ITEM FOR ENVIRONMENTAL COMMISSION AGENDA

NAME & NUMBER OF PROJECT: JUNIOR LEAGUE OF AUSTIN COMMUNITY IMPACT CENTER
SPC-2016-0055C

MEMORANDUM

SUBJECT: Junior League of Austin Community Impact Center
Case No. SPC-2016-0055C

Cut Fill Exhibit

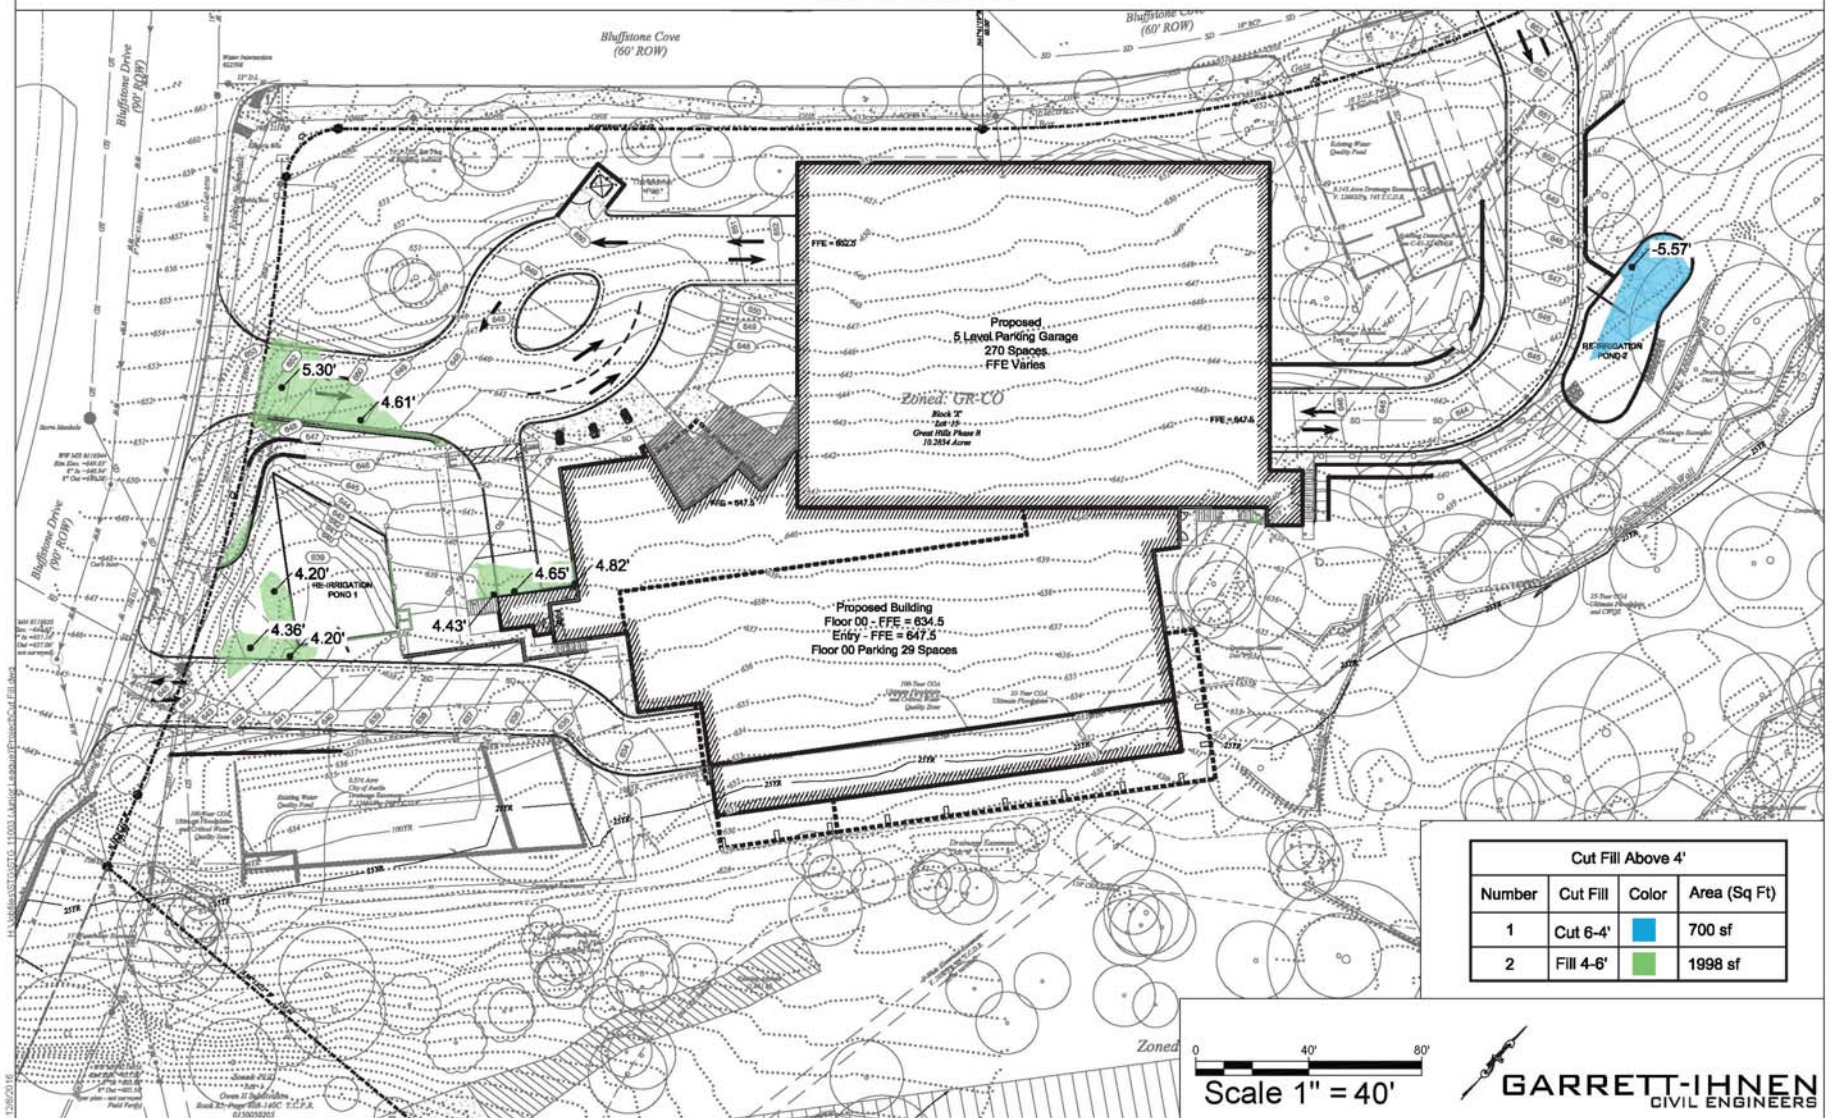
Fill above 4' to 5.3' [13-15-235(a)]

No fill on any lot or other land within the subdivision, except within the roadway right-of-way, shall exceed a maximum of (4) feet of depth.

Cut above 4' to 5.57' [13-15-235(b)]

No cut on any lot or other land within the subdivision, except within the roadway right-of-way, shall exceed a maximum of (4) feet of depth.

H:\Jobs\11003 (Junior League)\Exhibits\Construction on Slopes.dwg
12/12/2016

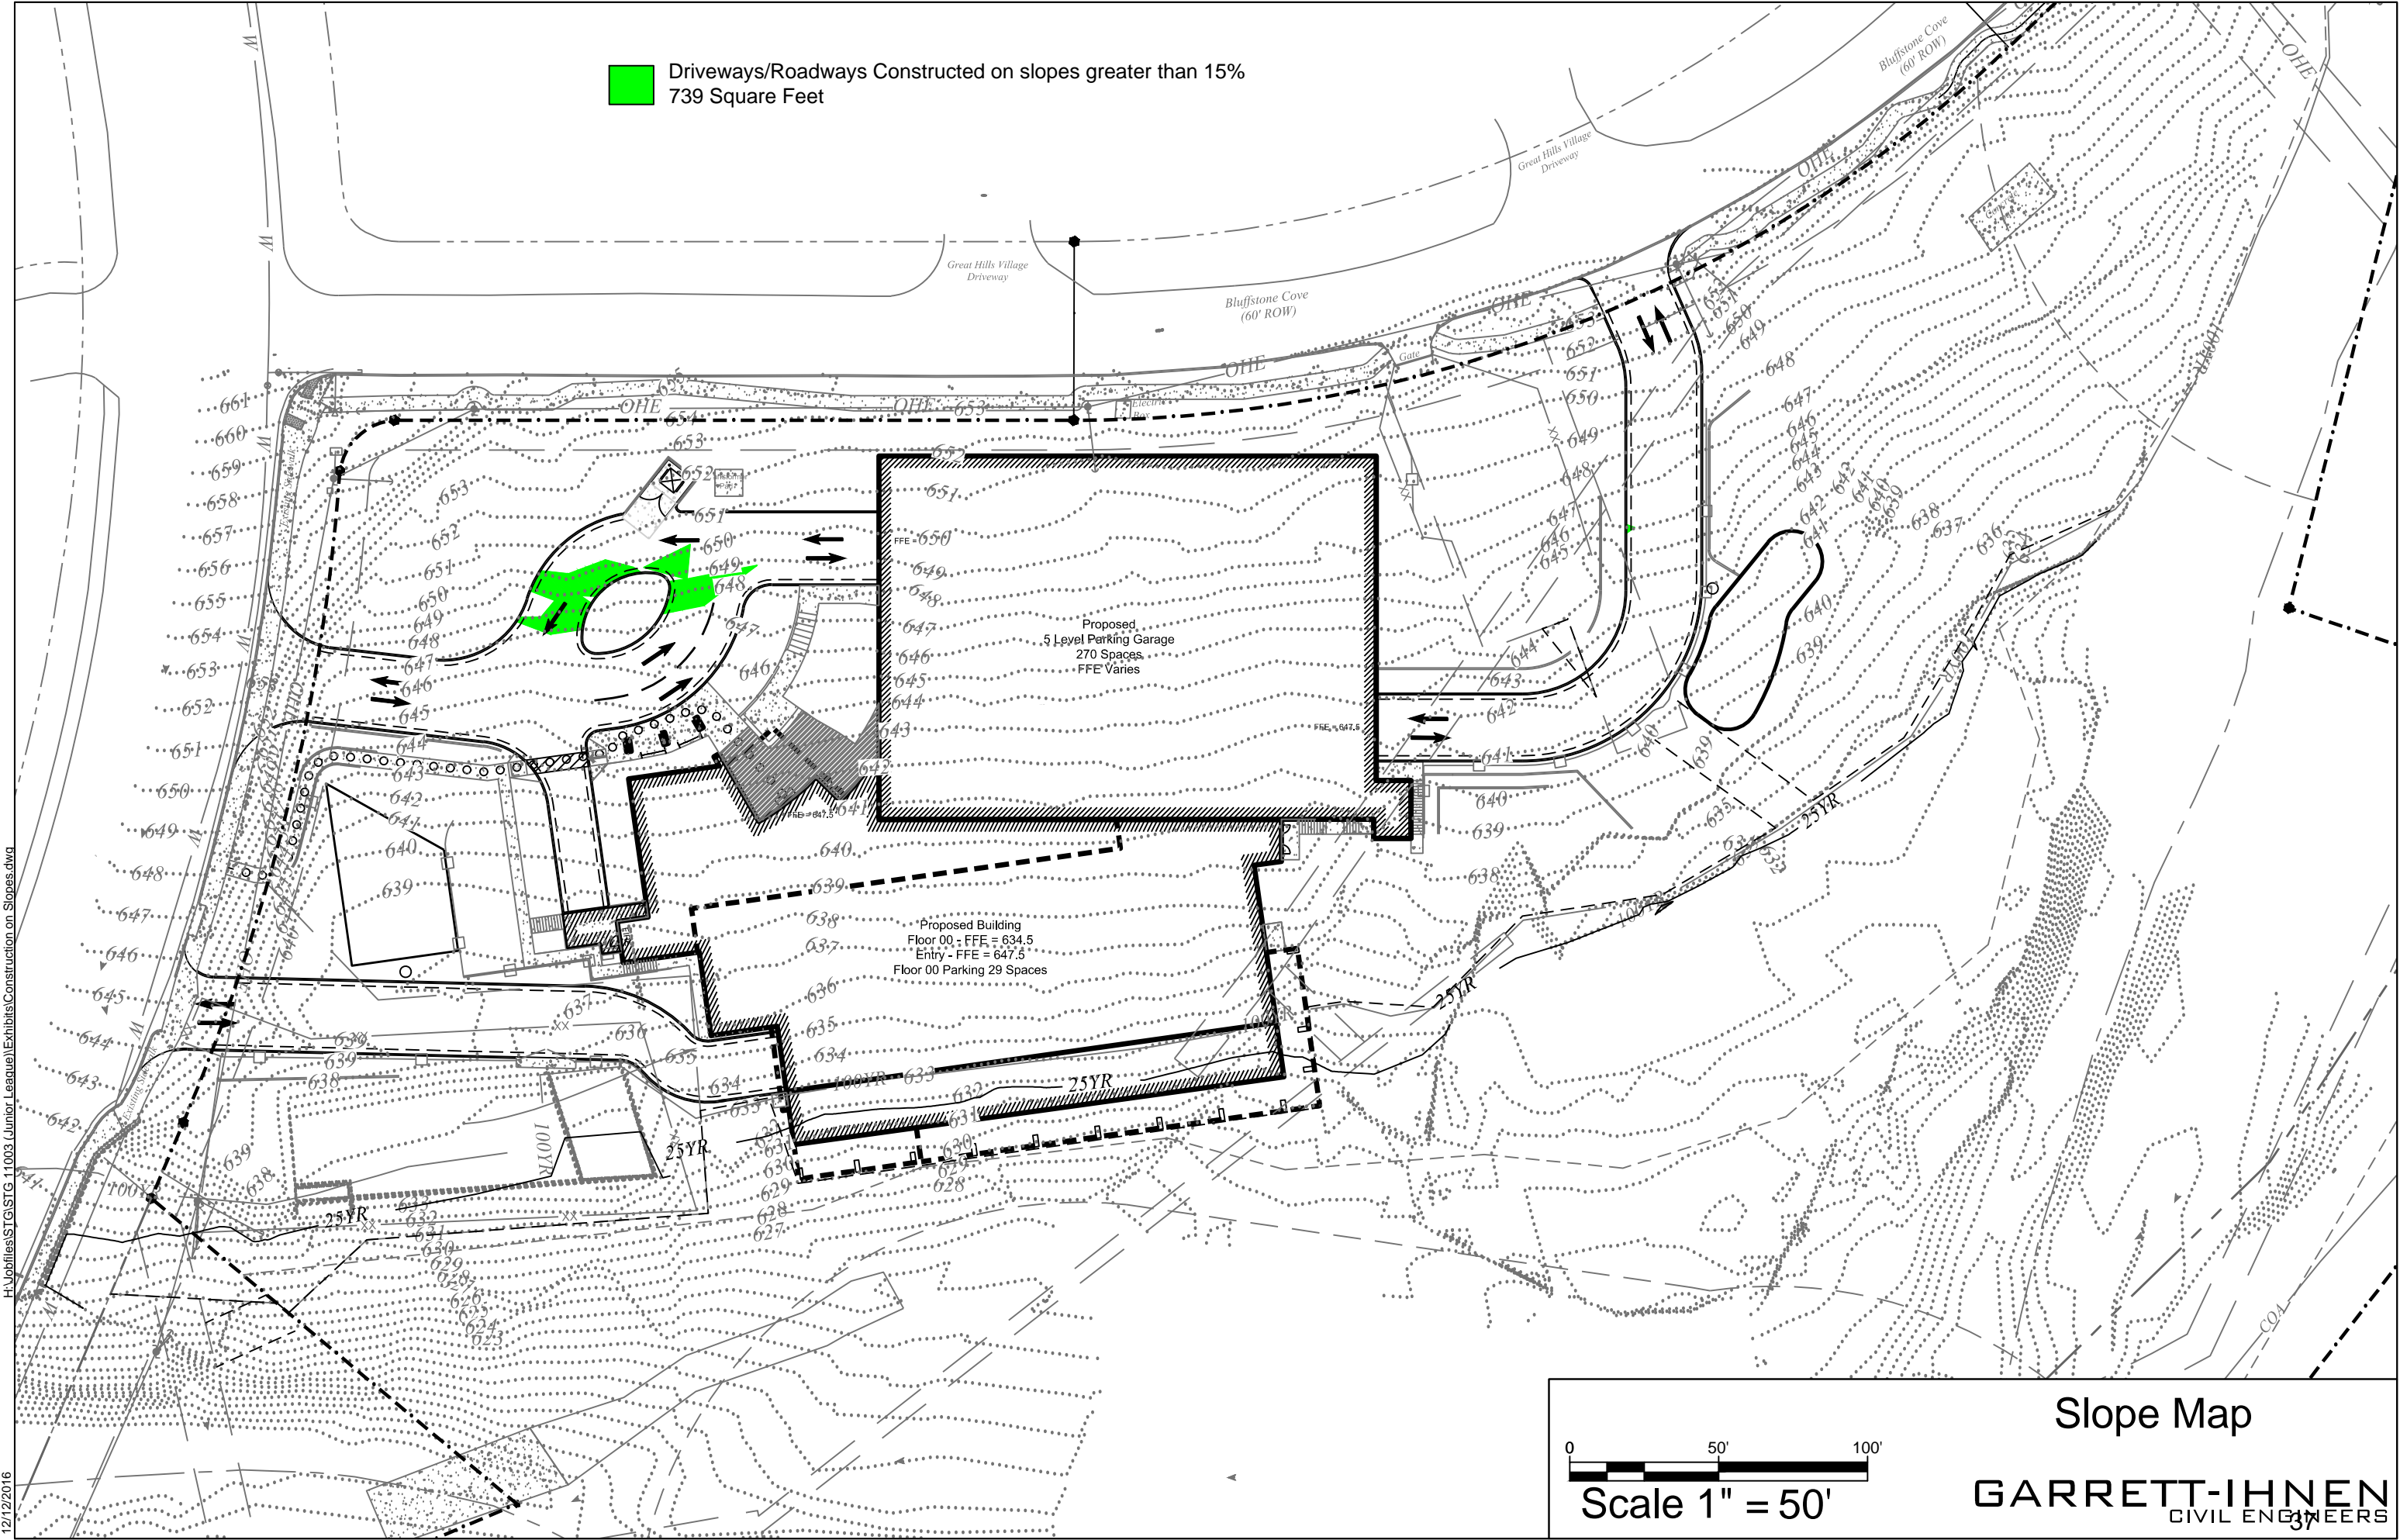
Construction on Slopes [13-15-237(a)]

No roadways or driveways shall be constructed on slopes in excess of fifteen (15) percent except where necessary to provide primary access to areas of flatter slopes, constituting a minimum of two (2) contiguous acres or building sites for at least five (5) residential units.

Due to the significant slope constraints on the site, the entry drive has been located to minimize cut/fill, impervious cover, and to avoid trees, while still providing access to the site.

Cut Fill Exhibit

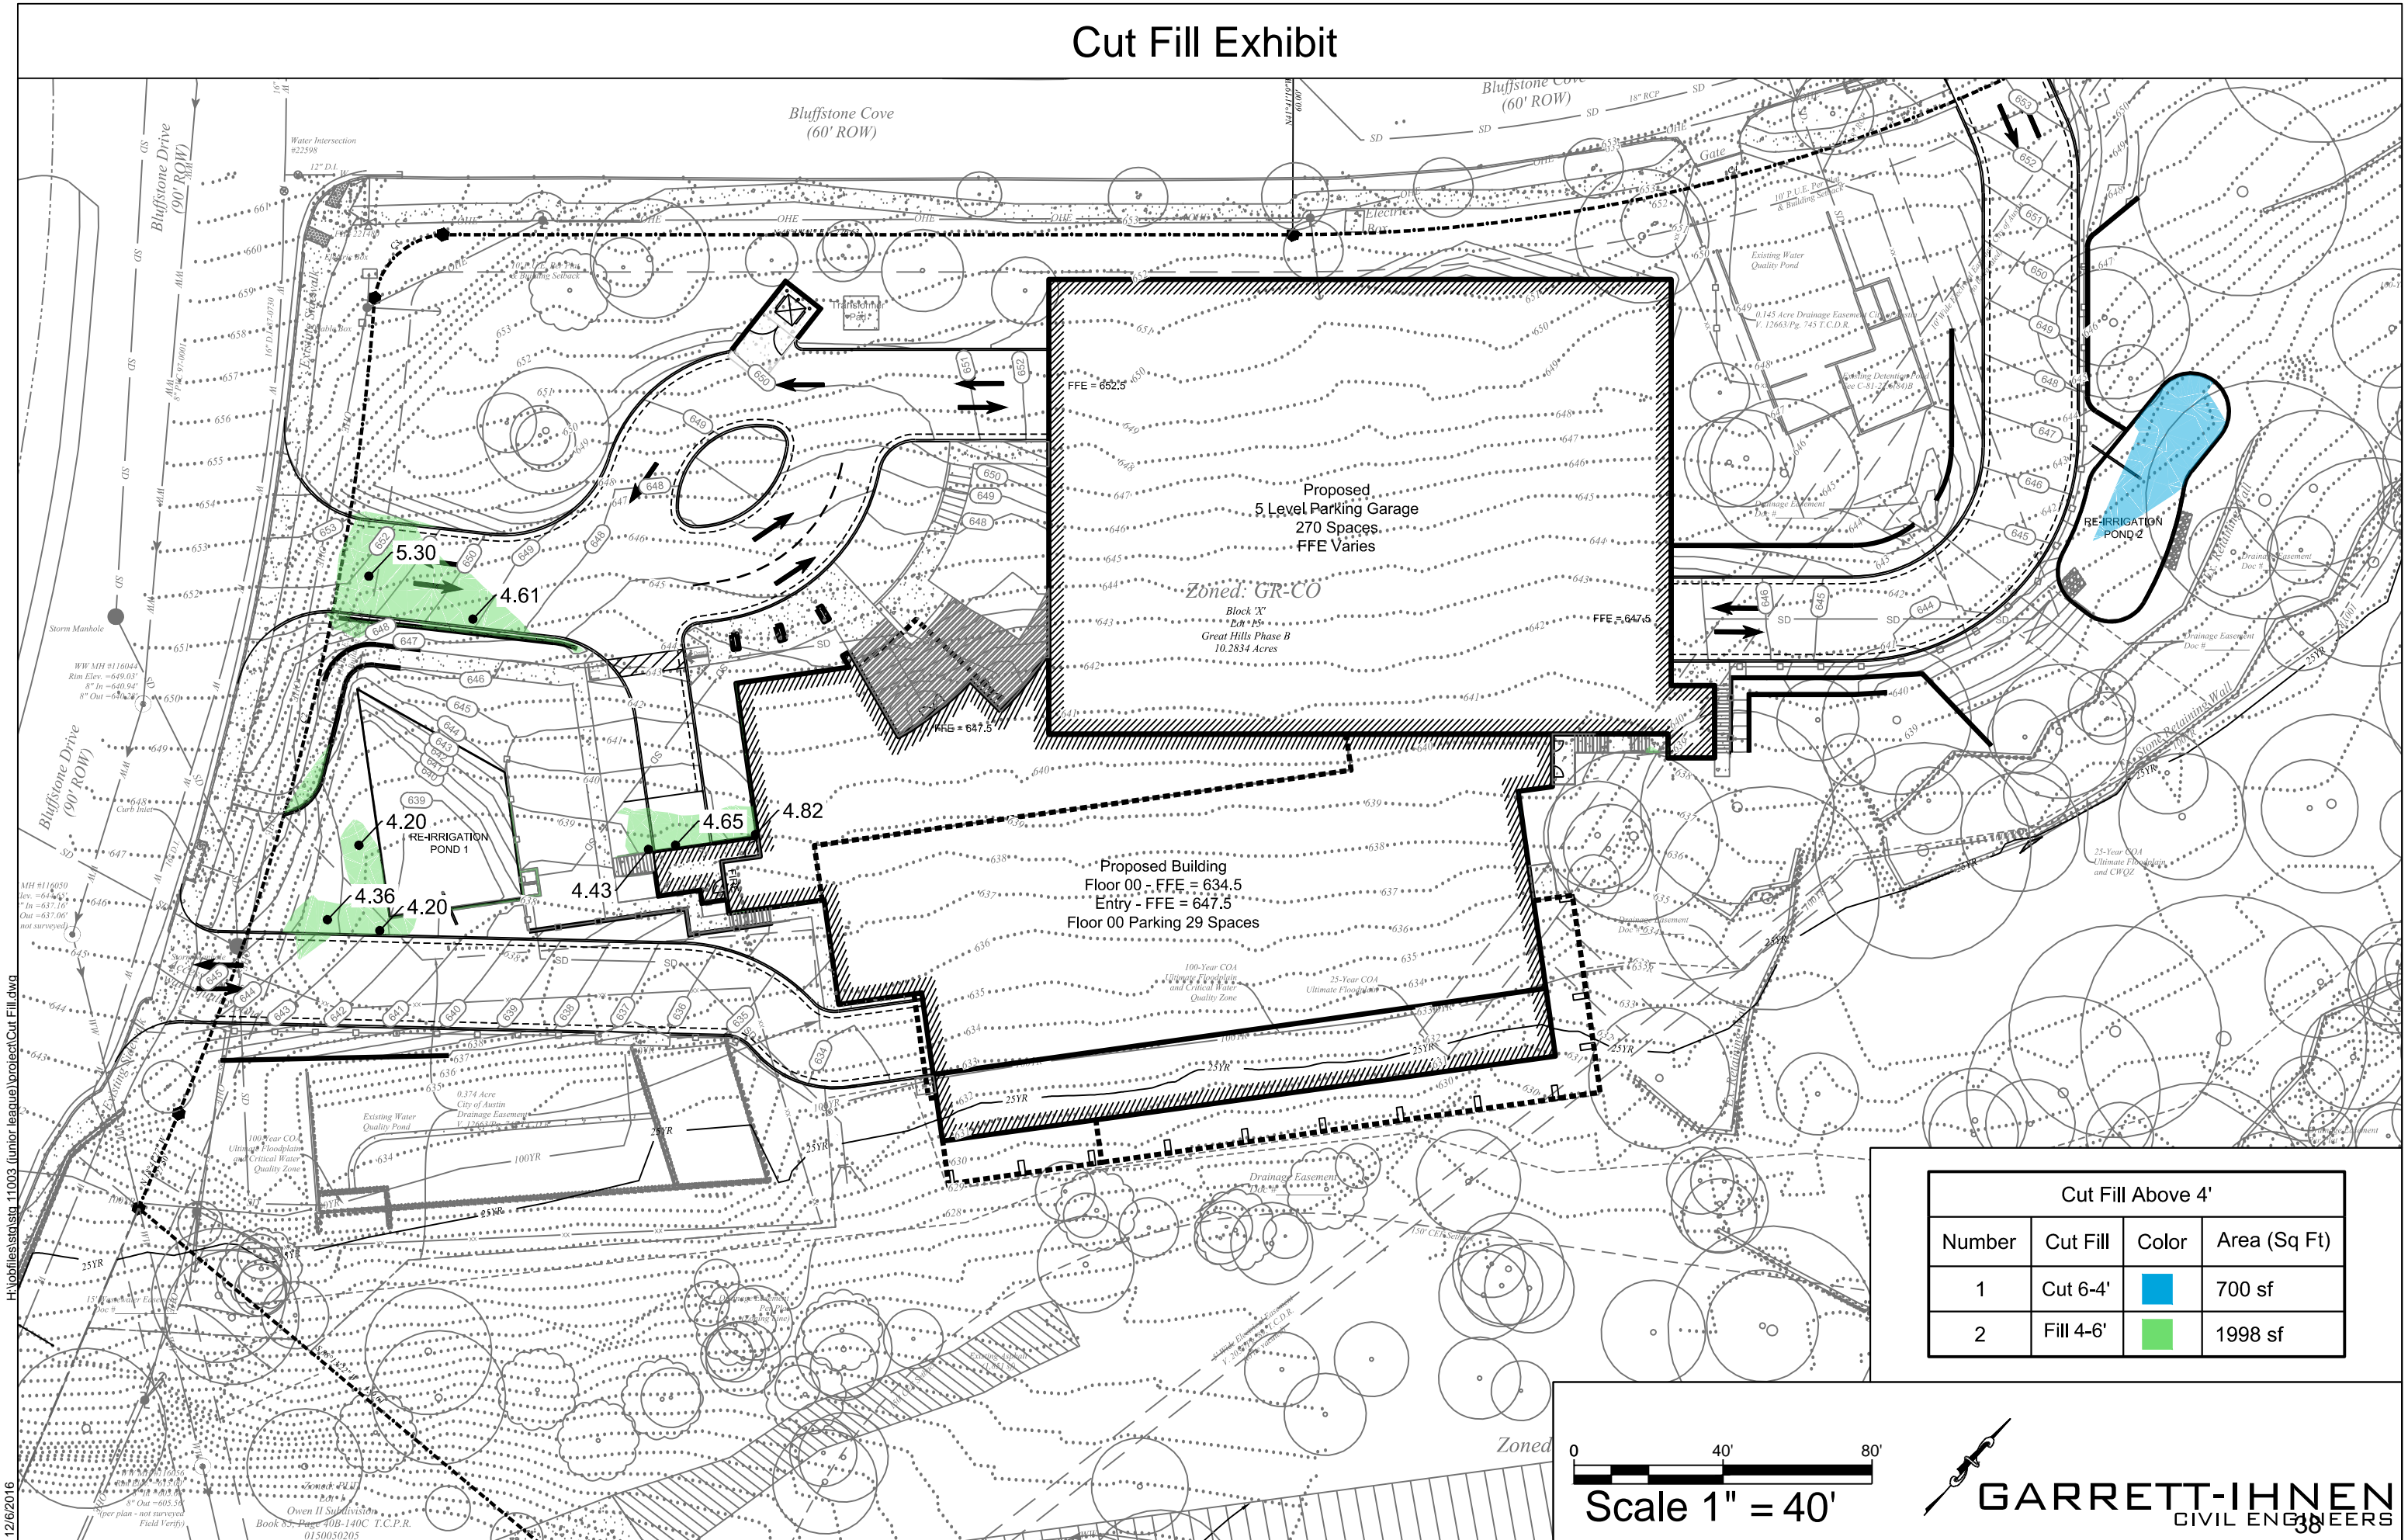
§13-15-235 (Cut above 4 feet): The 700 SF of cut between 4 feet and 6 feet is associated specifically with the location required for a retention/re-irrigation pond to the east of the proposed structure. The small window available for development on the site requires separate retention/re-irrigation facilities due to the topographic constraints, Critical Environmental Feature buffers, protected trees, floodplain, and waterway setbacks on the site. This eastern pond is required to treat runoff from a portion of the garage and the eastern entrance to that garage.

§13-15-235 (Fill above 4 feet): The 1,998 SF of fill between 4 feet and 6 feet is associated with the western retention/re-irrigation pond required by the Settlement Agreement, the primary entry drive onto the site, and a required loading area on the south side of the building.
